## **PLAN REVIEW SHEET**

**Telephone:** 704-353-0018 **Petition:** 2016-116

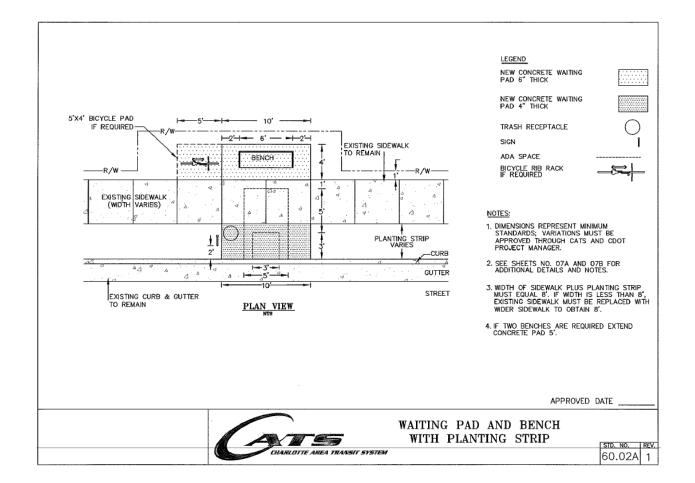
This site is located on an existing bus route at a traffic signal. The Petitioner is requested to provide and construct two new bench pads for a relocated bus stop pair on South Tryon Street near the signalized intersection of Beam Road.

Below is an image of the standard detail (60.02A) for the requested bench pad pair. One of these requested bench pads should be along the frontage of the site. The other requested bench pad should be opposite the site, but still within public right-of-way, tying into existing sidewalk.
